ILT Training FSM Update

comments #463, 45, 230, 481

Jeff Slavick (Broadcom)

Adee Ran (Cisco)

Figure 178B-10—Training control state diagram

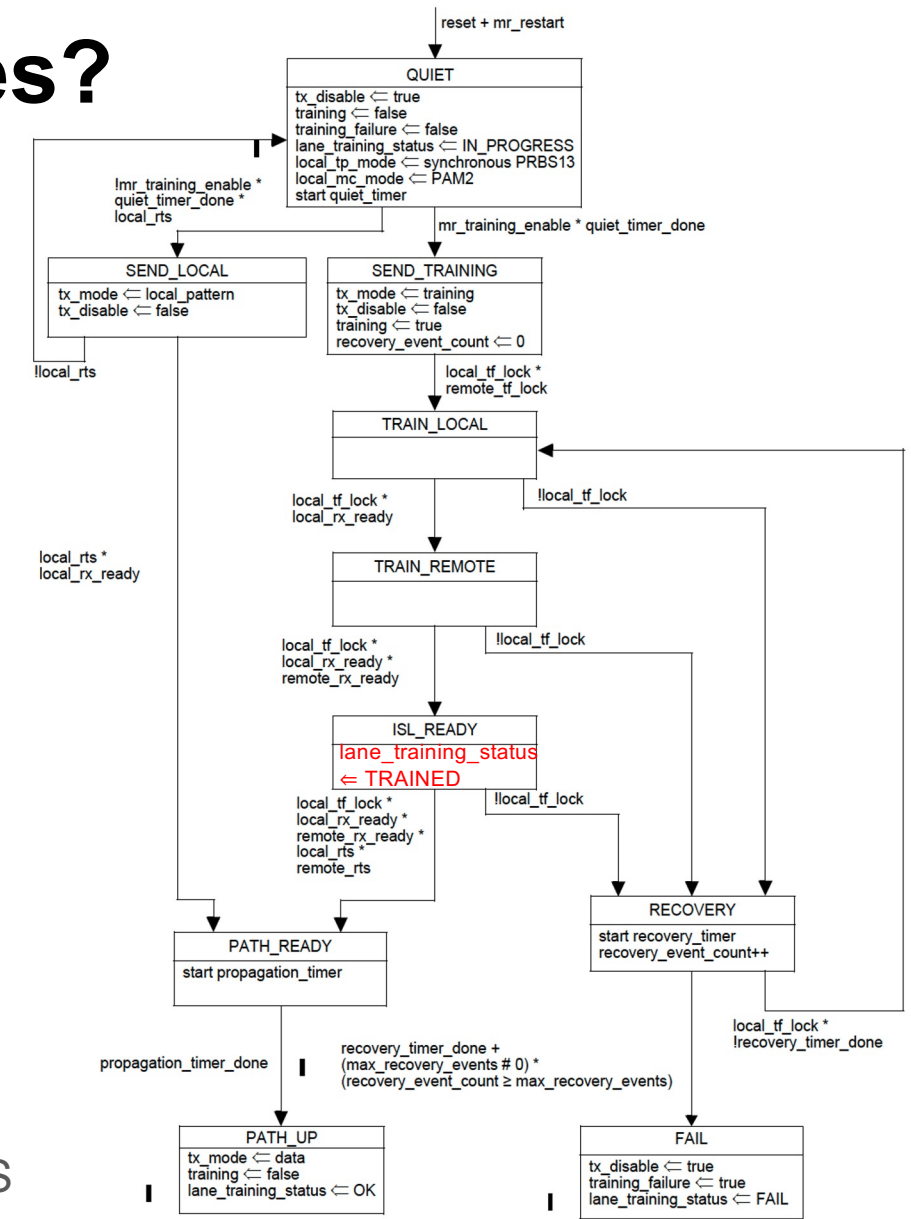
peer & local rx rdy: Existing definition of isl_ready is valid. After local and peer Rx are done adapting.

Adj Rx done adapting: Add a new lane_training_status state of TRAINED that indicates local_rx_ready and remote_rx_ready are both true. This is used in training_status state generation which is mapped to SIGNAL_OK

Adj Rx receiving data clk: Existing definition of remote_rts is valid. (true when CT=0 on all lanes) This is mapped in to SIGNAL_OK

SIGNAL_OK primitive is used to transfer the above states to the adjacent interface and is mapped from training_status variable. Define the states of training_status to be as follows:

FAIL: Any lane_training_status is FAIL

OK: All lane_training_status are OK

READY: remote_rts is true AND all lanes have lane_training_status of TRAINED or OK with at least one lane being TRAINED.

IN_PROGRESS: At least one lane has lane_training_status of IN_PROGRESS and no lanes have lane_training_status of FAIL.

Figure 178B-9—RTS update state diagram

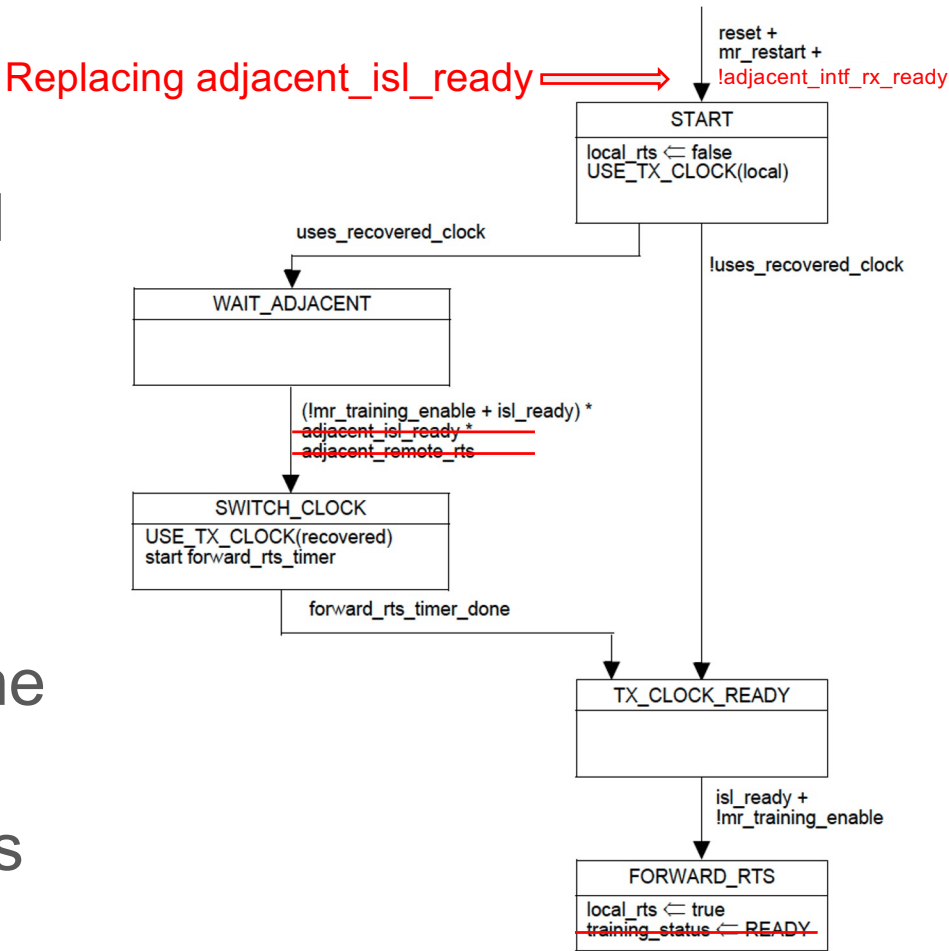
This diagram is new for ILT compared to legacy PMD Control functions (Clause 162, 136, 93, 72).

Its addition is to support Path-Startup and should be limited to changing the Tx state to “Ready To Send” state.

This assignment of the training_status variable needs to be removed from (Figure 178B-9) as that’s information to be sent to another interface, not used by the local interface.

Make RTS update state diagram be just about the Tx

Remove adjacent_remote_rts and adjacent_isl_ready variables definitions and add adjacent_intf_rx_ready.

adjacent_intf_rx_ready

Boolean variable that is derived from the received SIGNAL_OK primitive on the service interface. It is set to TRUE when SIGNAL_OK is either READY or OK and FALSE otherwise.

Figure 178B-10—Training control state diagram

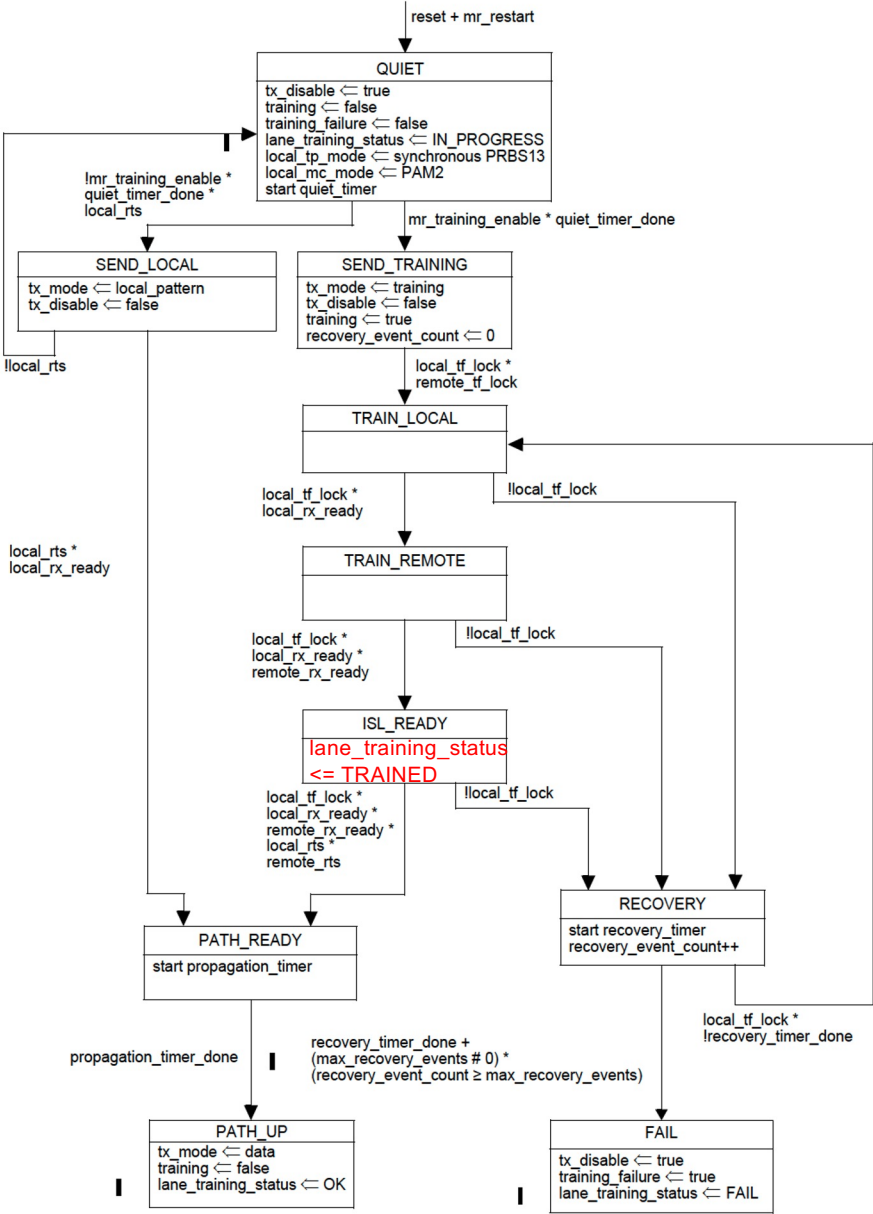
Changes to Figure 178B-10 highlighted in red.

Define the states of training_status in 178B.7.2.1 to be as follows:

- FAIL:** Any lane_training_status is FAIL
- OK:** All lane_training_status are OK
- READY:** remote_rts is true AND all lanes have lane_training_status of TRAINED or OK with at least one lane being TRAINED.
- IN_PROGRESS:** At least one lane has lane_training_status of IN_PROGRESS and no lanes have lane_training_status of FAIL.

Figure 178B-9—RTS update state diagram

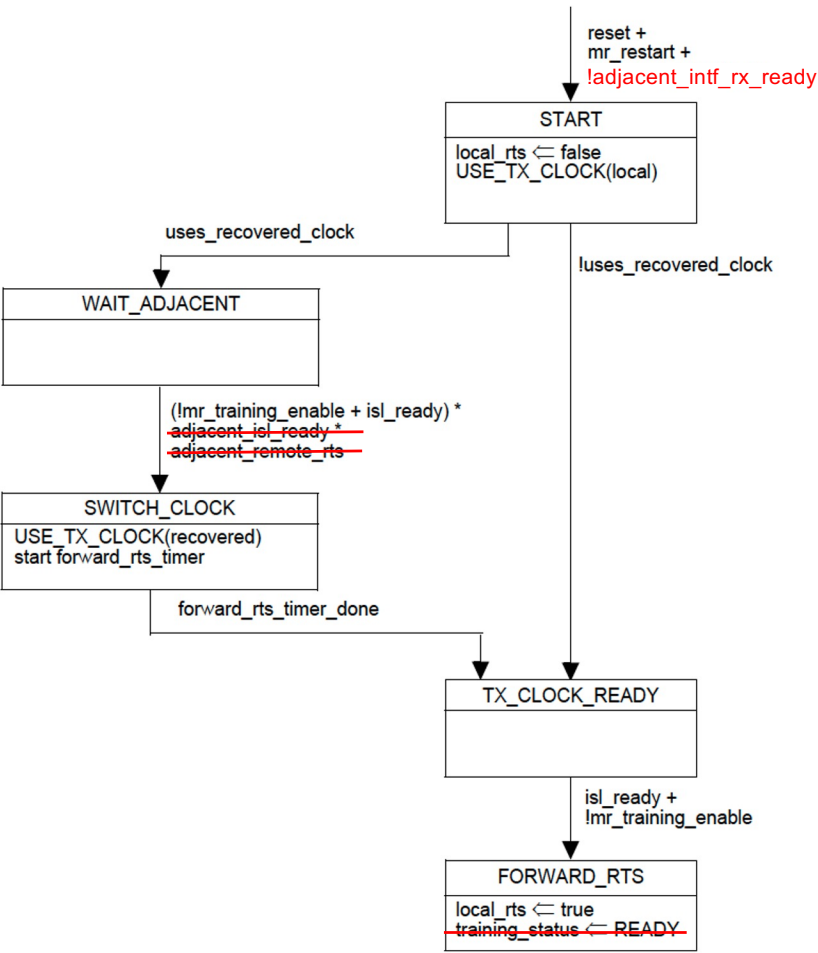
Changes to Figure 178B-9 indicated in red.

Remove adjacent_remote_rts and adjacent_isl_ready variables definitions and add adjacent_intf_rx_ready as follows:

adjacent_intf_rx_ready

Boolean variable that is derived from the received SIGNAL_OK primitive on the service interface. It is set to TRUE when SIGNAL_OK is either READY or OK and FALSE otherwise.

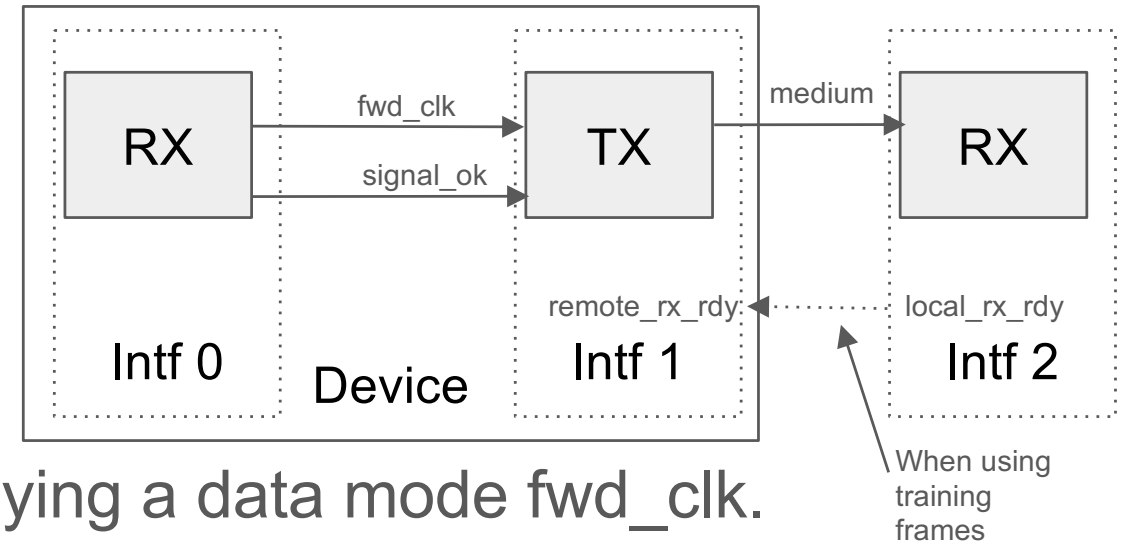
Add the following definition into 178B.3:

Adjacent interface:

Interface whose service interface is connected (directly or indirectly) with this interface. There may be multiple sub-layers between the two ILT interfaces. For example, in Figure 178B-1 the first AUI component above (left) of the PHY_XS and the first AUI component below (right) of the PCS (for the Physical Layer on the left) are adjacent interfaces of each other.

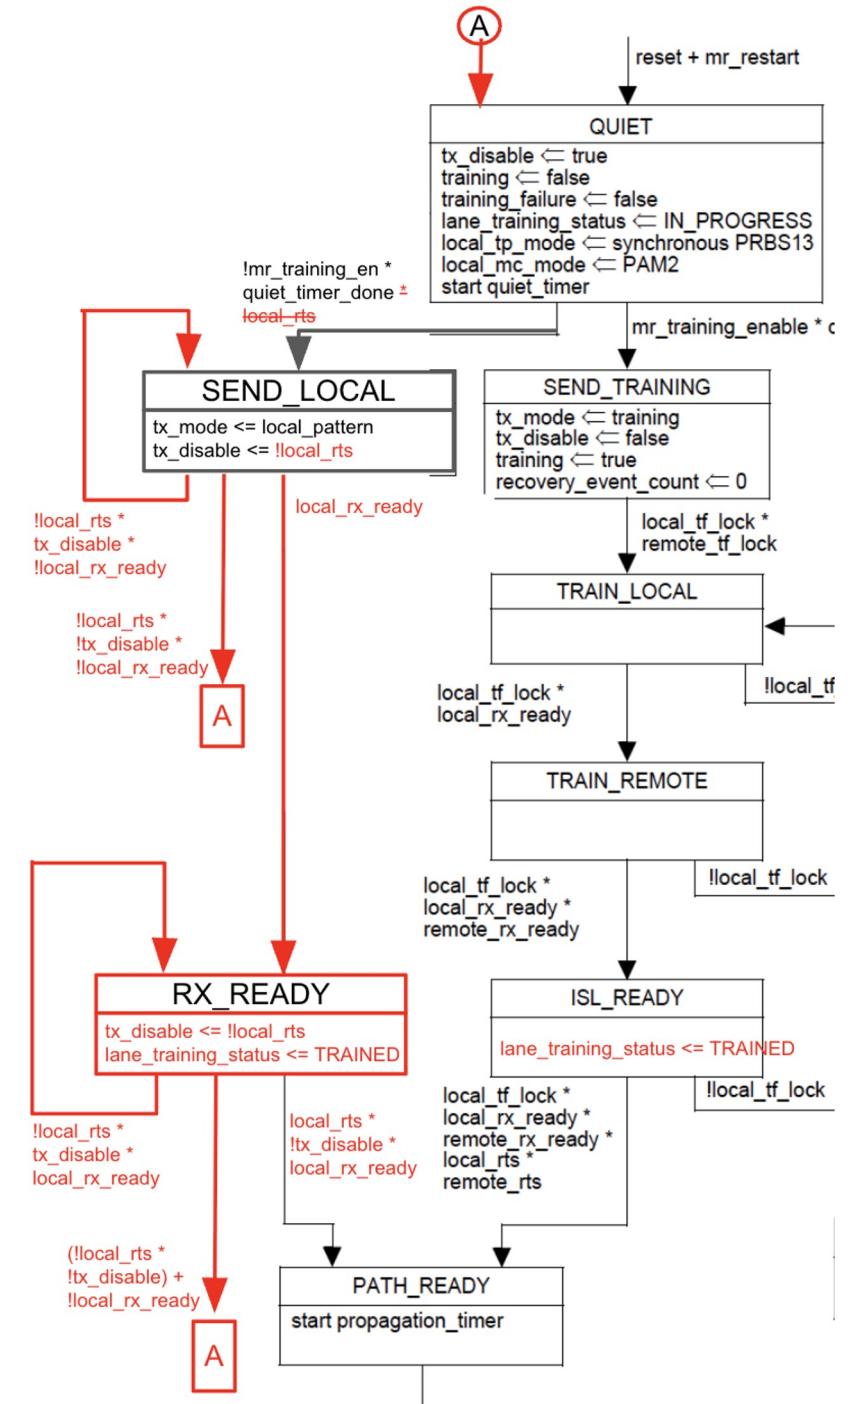
In local pattern mode Tx and Rx are disjoint - one can be ready while other is still “off”. The Tx needs to wait until it’s on mission clock (`local_rts = true` [item 1,2,3]) to begin transmitting, prior to peer Rx running adaptation. The Rx needs to adapt as soon as it sees data, and set `lane_training_status` to TRAINED when ready, which indicates the adjacent interface Tx may now swap to mission clock.

The following are the updates to Figure 178B-10 shown to right:

- Ensure Tx is squelched for at least the quiet timer duration. Then support either Tx or Rx completing first.
- Unsquelch Tx once its swapped to mission clock (`local_rts = true`)
- Set `lane_training_status` to TRAINED when Rx is ready
- Monitor if `local_rts` changes from true to false, go back to QUIET to squelch for a minimum period of time.
- Monitor if `local_rx_ready` changes from true to false, go back to QUIET to squelch for a minimum period of time.

Figure 178B-10—Training control state diagram

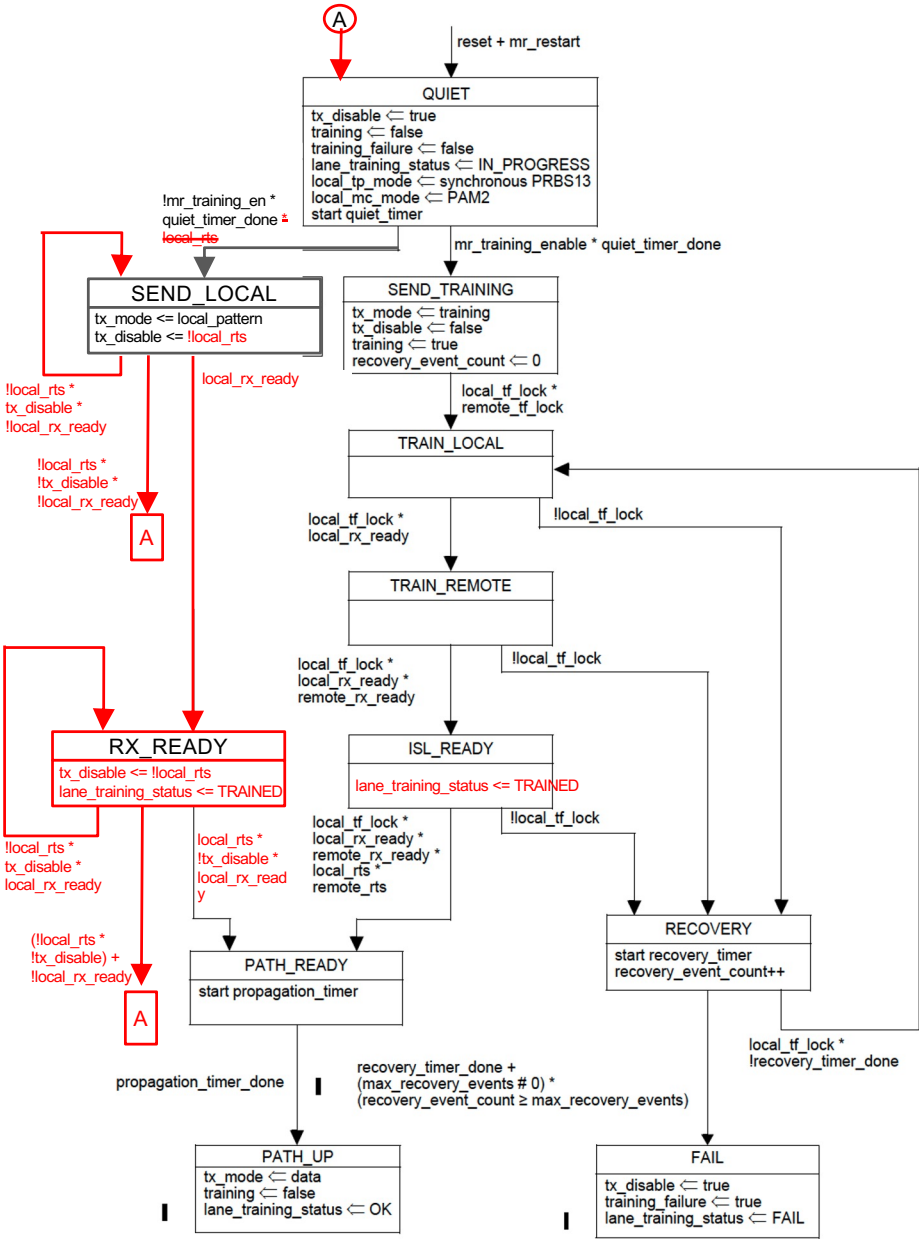
Changes to Figure 178B-10 highlighted in red.

Define the states of training_status in 178B.7.2.1 to be as follows:

FAIL: Any lane_training_status is FAIL

OK: All lane_training_status are OK

READY: remote_rts is true AND all lanes have lane_training_status of TRAINED or OK with at least one lane being TRAINED.

IN_PROGRESS: At least one lane has lane_training_status of IN_PROGRESS and no lanes have lane_training_status of FAIL.

Figure 178B-9—RTS update state diagram

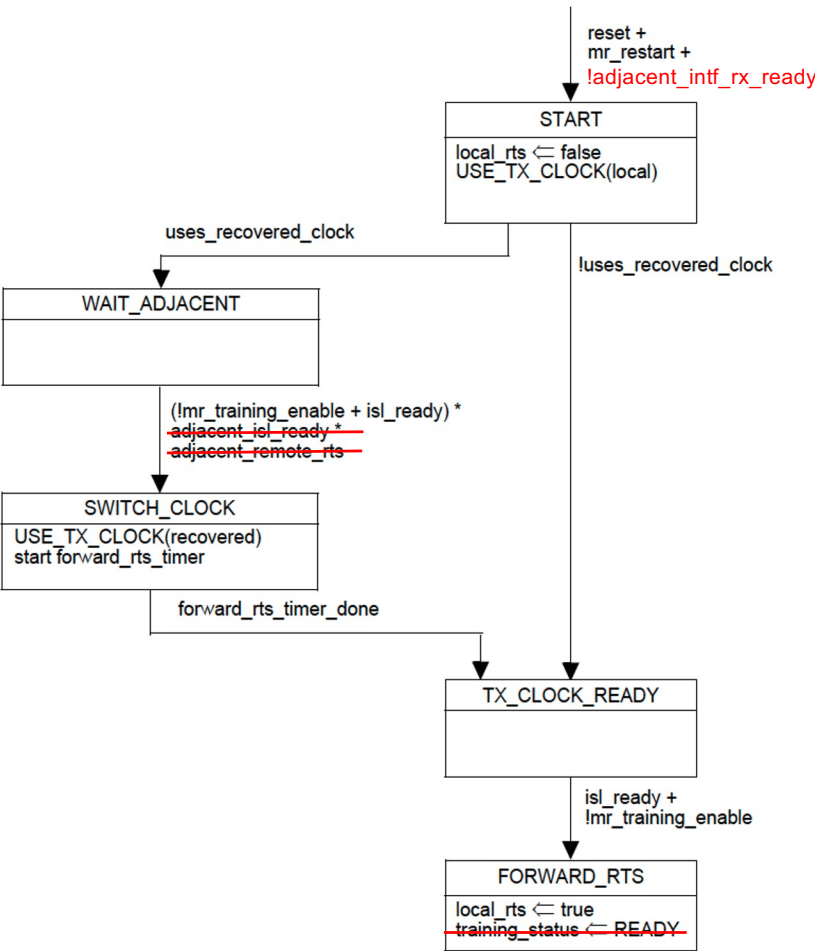
Changes to Figure 178B-9 indicated in red.

Remove adjacent_remote_rts and adjacent_isl_ready variables definitions and add adjacent_intf_rx_ready as follows:

adjacent_intf_rx_ready

Boolean variable that is derived from the received SIGNAL_OK primitive on the service interface. It is set to TRUE when SIGNAL_OK is either READY or OK and FALSE otherwise.
